**AGENDA
TOWN OF PITTSFORD
PLANNING BOARD
NOVEMBER 13, 2023**

Bergmann Associates, Oak Hill Country Club (145 Kilbourn Road) Clubhouse Renovations
Preliminary/Final Site Plan and Special Use Permit

TOWN OF PITTSFORD
DEVELOPMENT REVIEW COMMITTEE – Planning Comments
For Planning Board Meeting 11/13/23

GRADING AND EROSION CONTROL PLAN

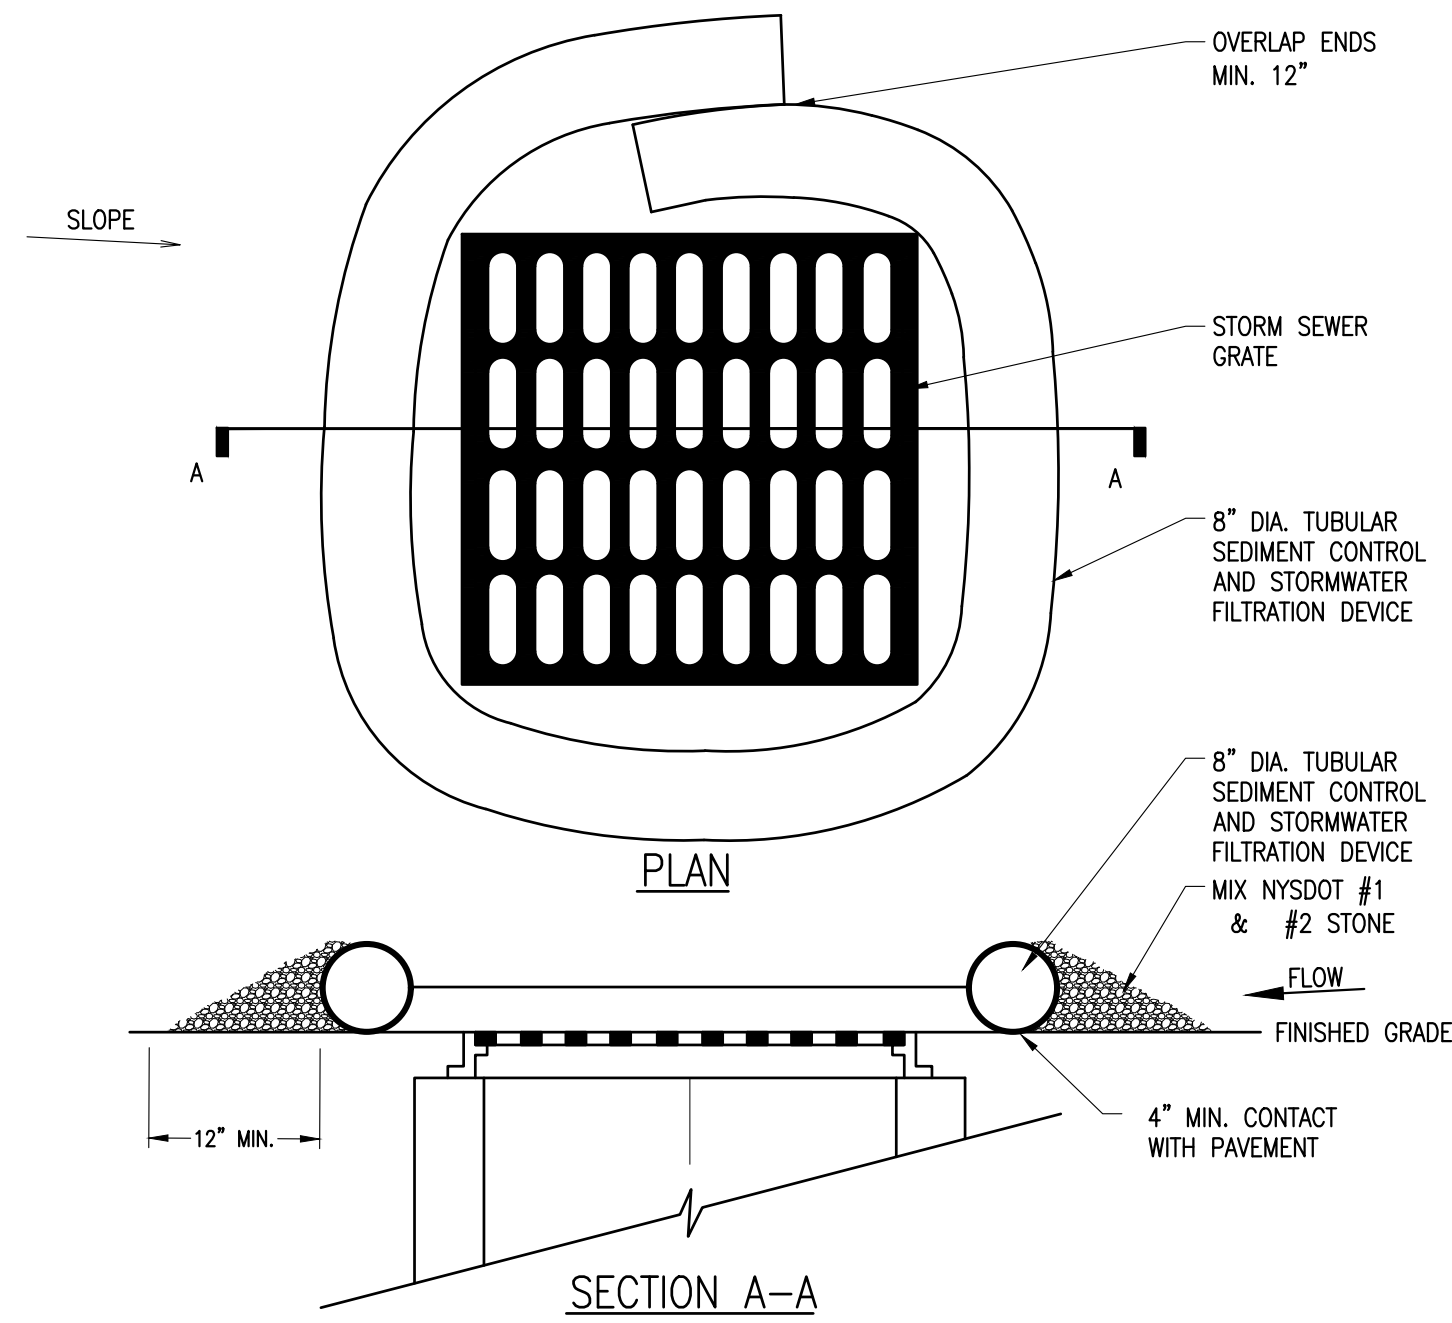
13. Please provide the location of the proposed topsoil pile on the grading and erosion control plan. Please include erosion and sediment control around the perimeter of the pile. (TRE)

GREASE INTERCEPTORS - TRAFFIC N.T.S.

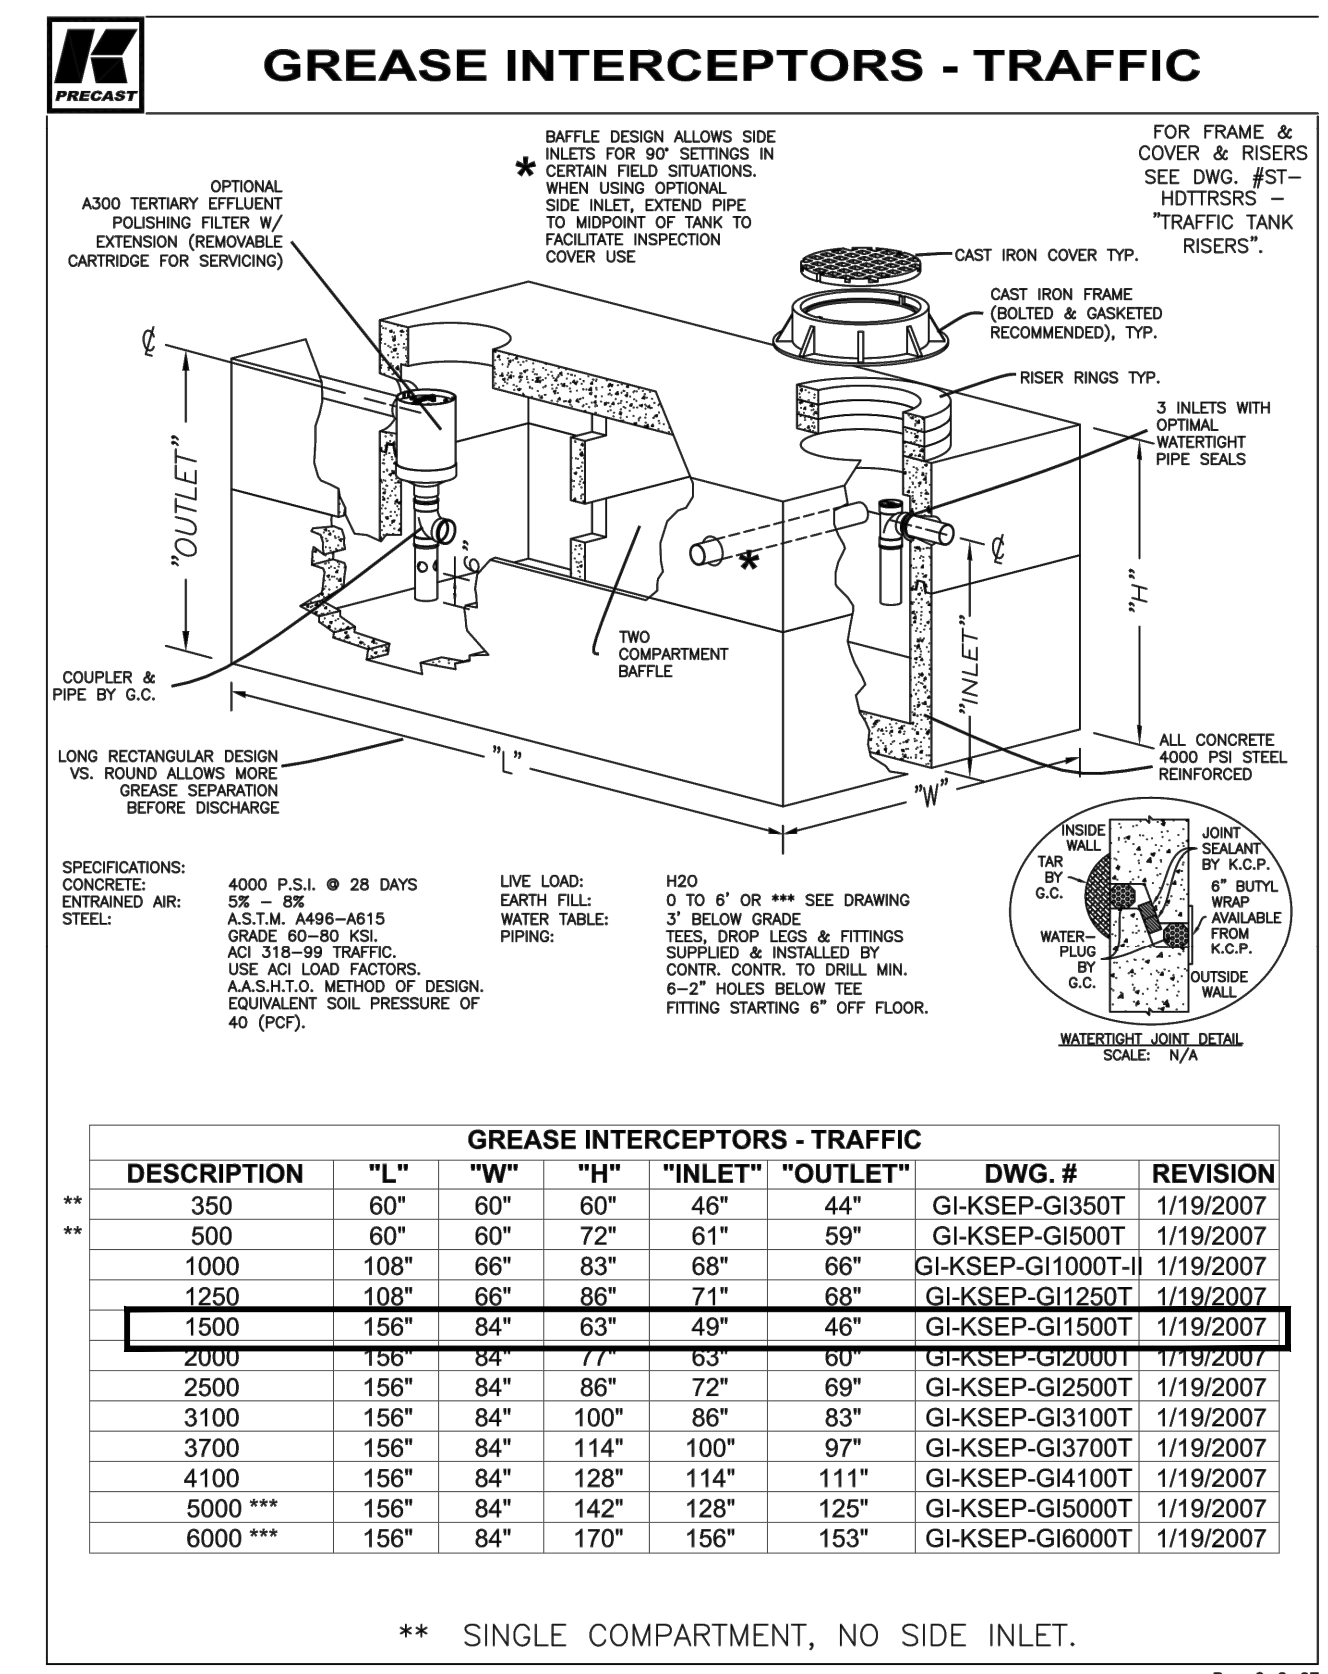
5. Plans indicate a 1,500-gallon grease interceptor. Please provide sizing calculations for the proposed grease chamber. (TRE)
6. It appears that an existing holding tank (possibly an existing grease chamber) is located near the proposed sanitary sewer connection. Please provide additional information regarding this structure. If this is an existing tank to be abandoned, it will be required to be pumped out, have its top slab broken, and be filled with gravel, prior to abandonment. (TRE)
7. It is recommended that cleanouts be provided outside of the proposed building with an orientation to allow cleaning in a downstream direction. (TRE, PSD)

L-101
 Outdoor Patio Site Plan

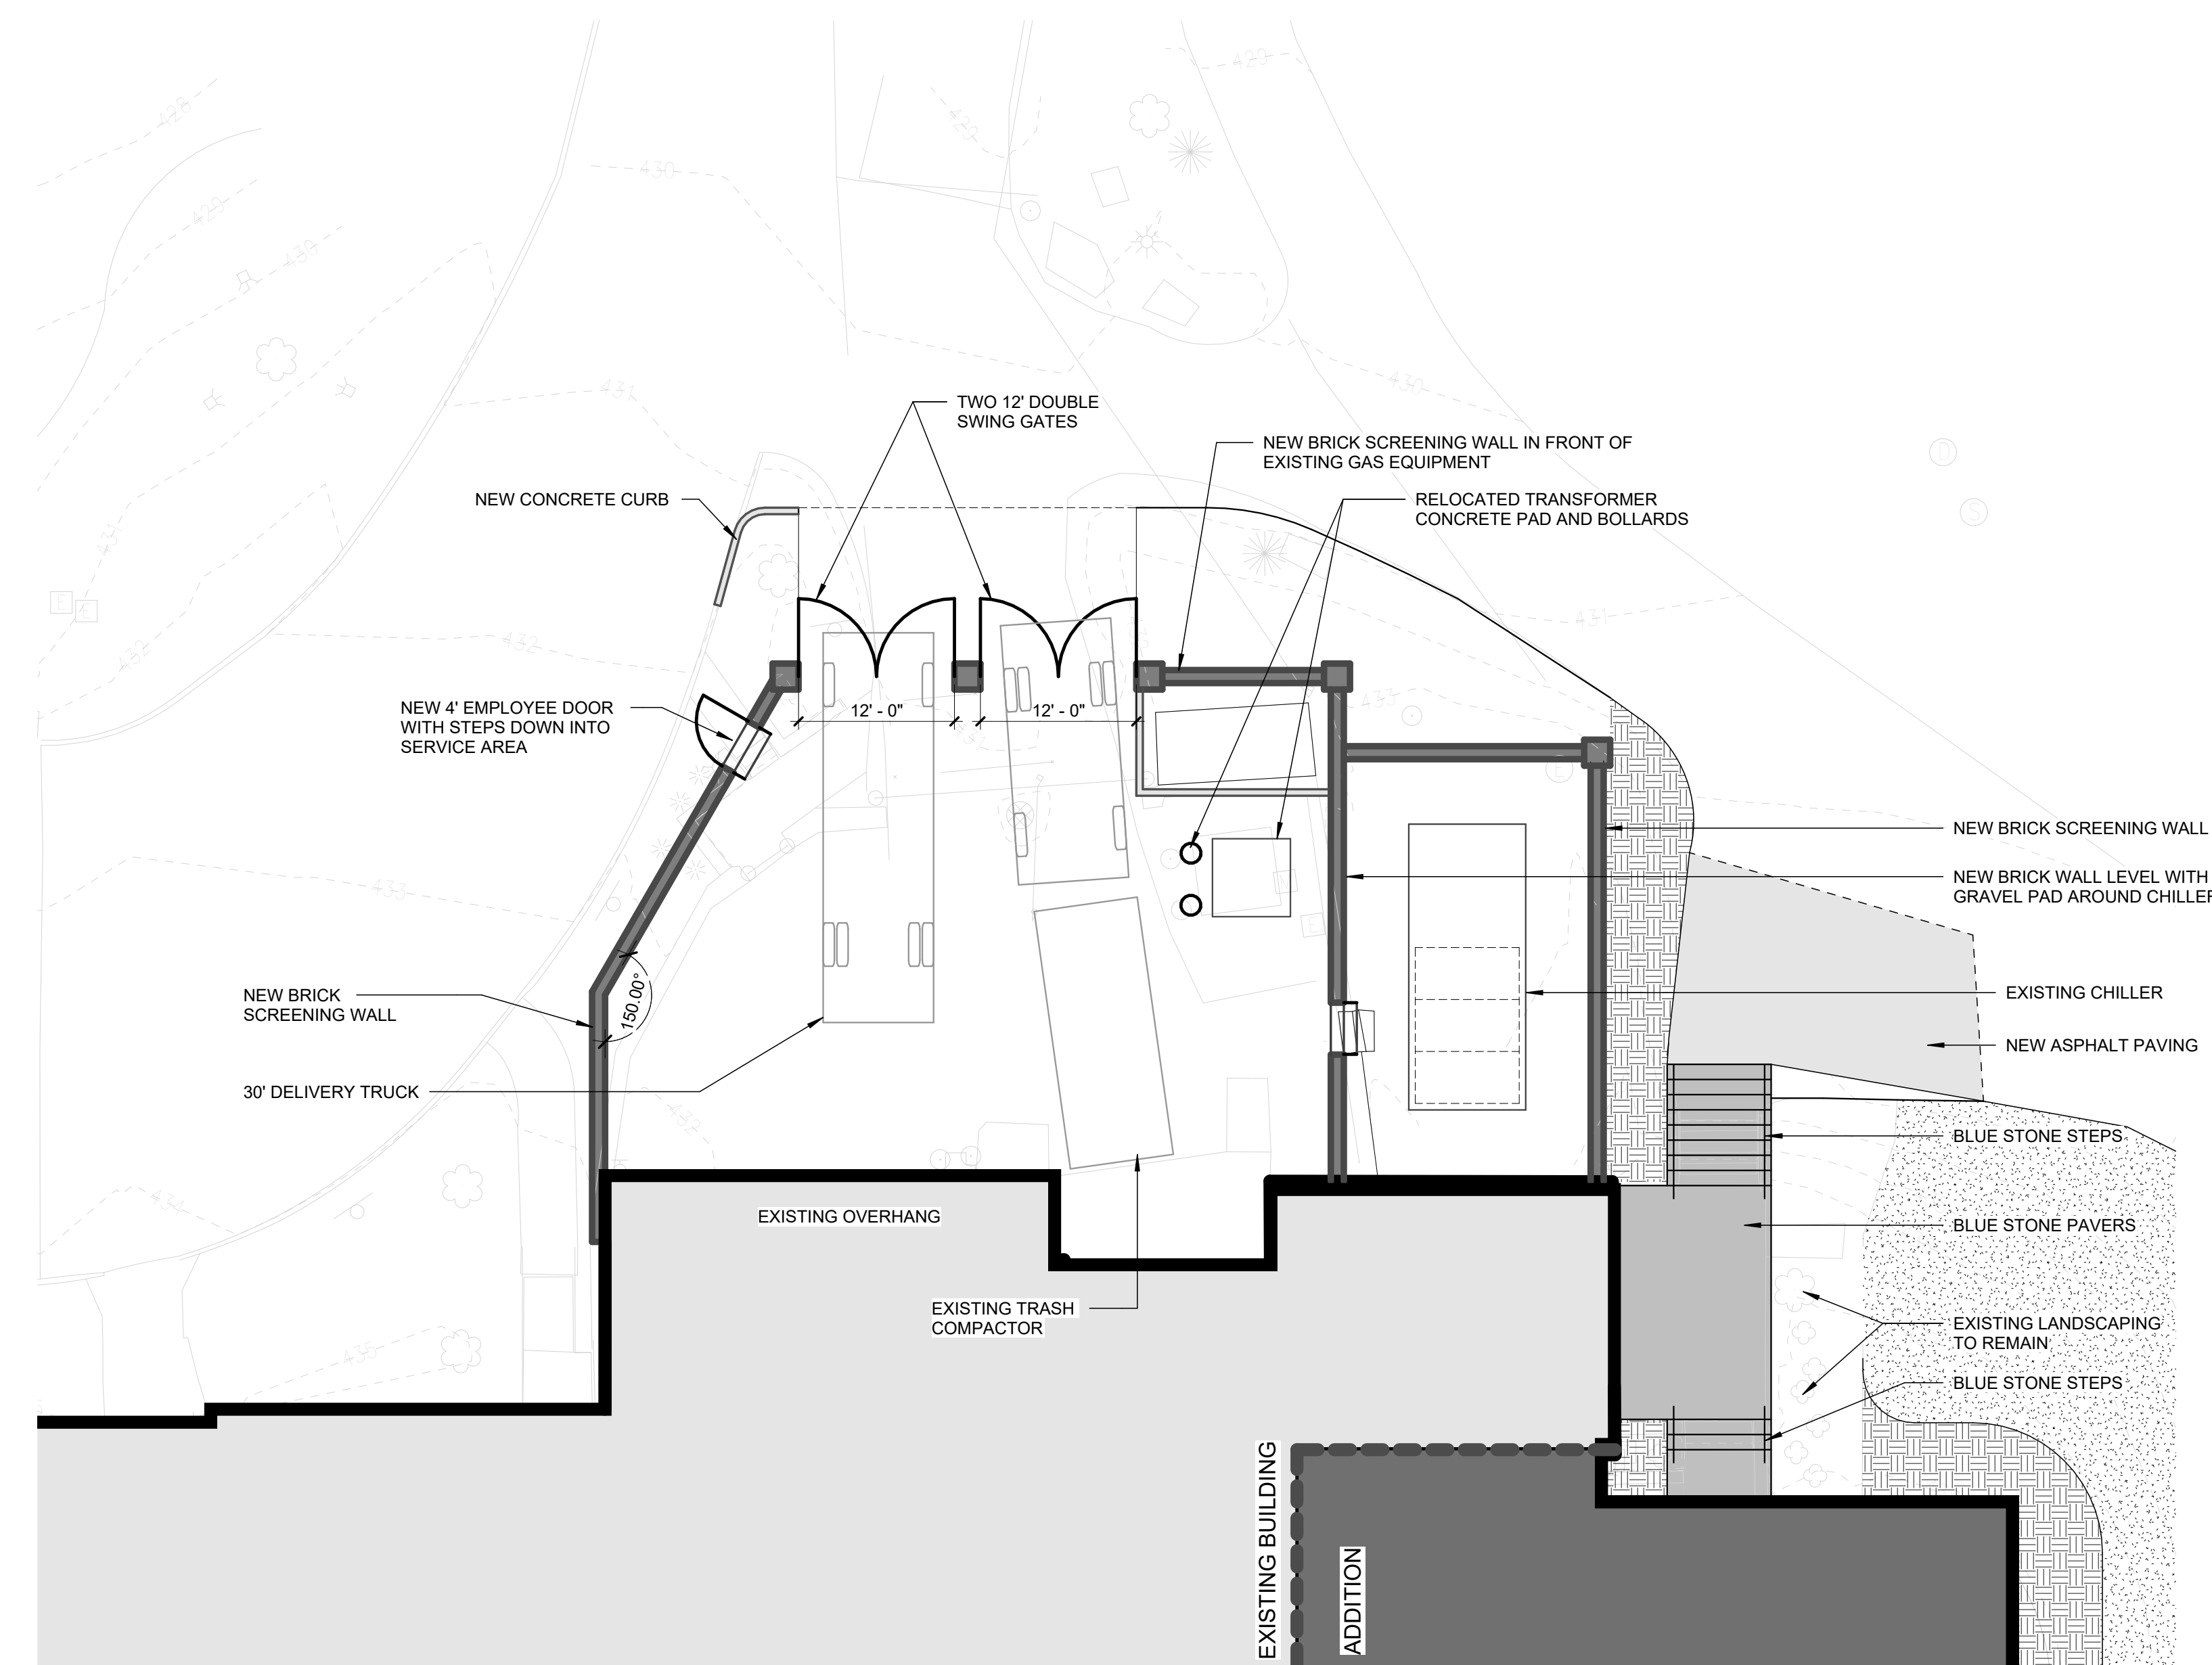
22. Please include details for the “double-sided fireplace” and “linear low-profile fireplace” shown on Sheet L101. (DPW)
23. Please verify the location of emergency gas shut offs for proposed gas fireplaces. (DPW)
24. Site entrances and roadways may not be blocked to impede emergency access at any time during construction. The road base shall be suitable for emergency vehicles. A public safety plan should be included in the plan set. (DPW)

SOUTH ELEVATION - BALLROOM

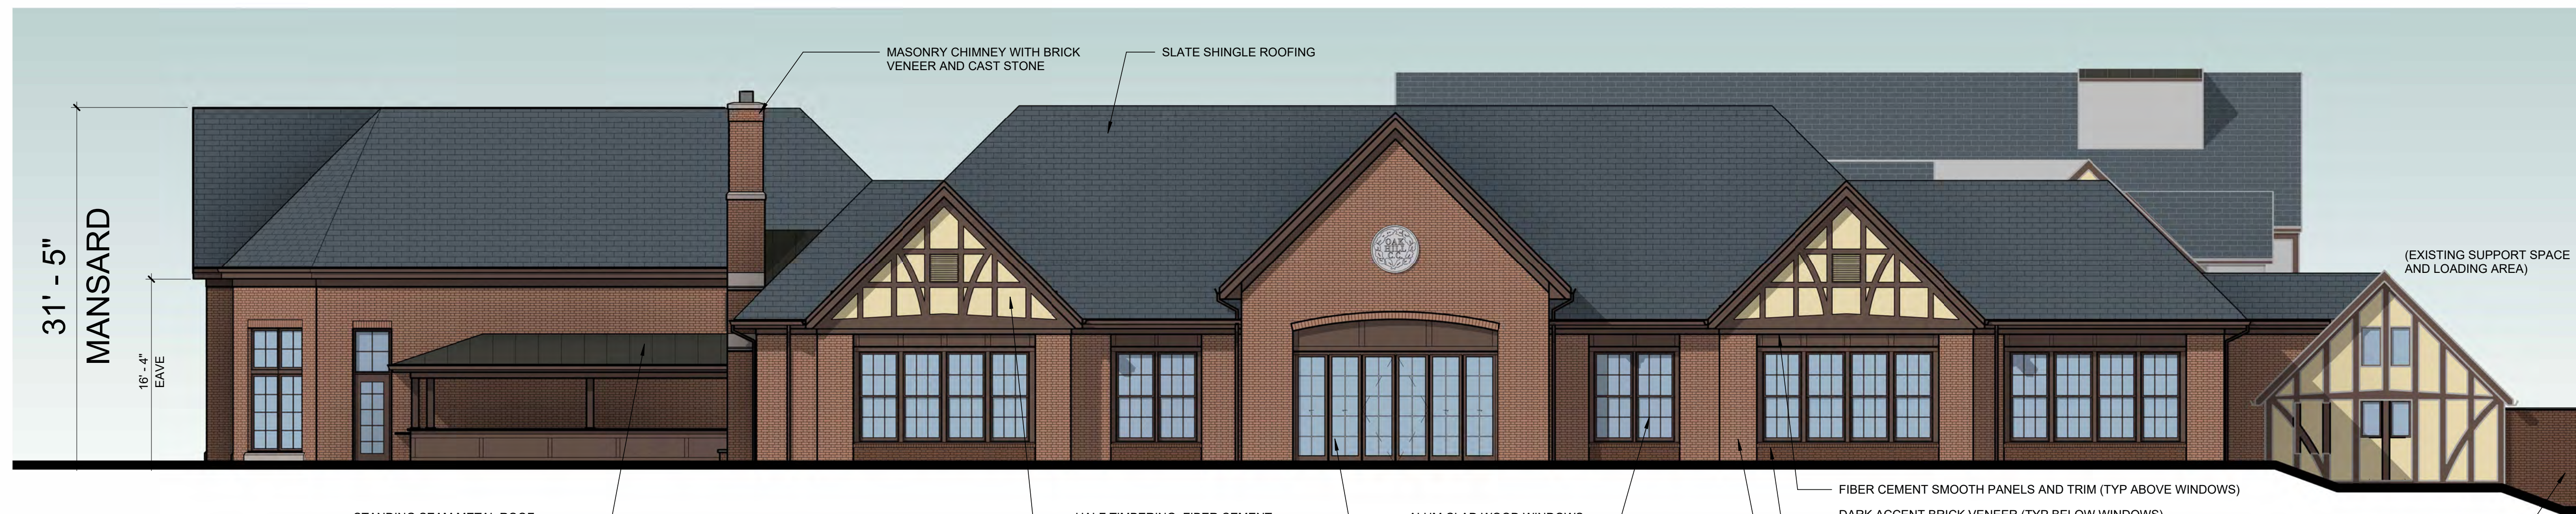
25. Will the proposed expansion be served by the water service within the existing building, or will a new water service be required? (TRE)
26. A rendering was provided for the south and east building elevations. Please provide elevations that include the proposed patio/outdoor seating space. (DPW)
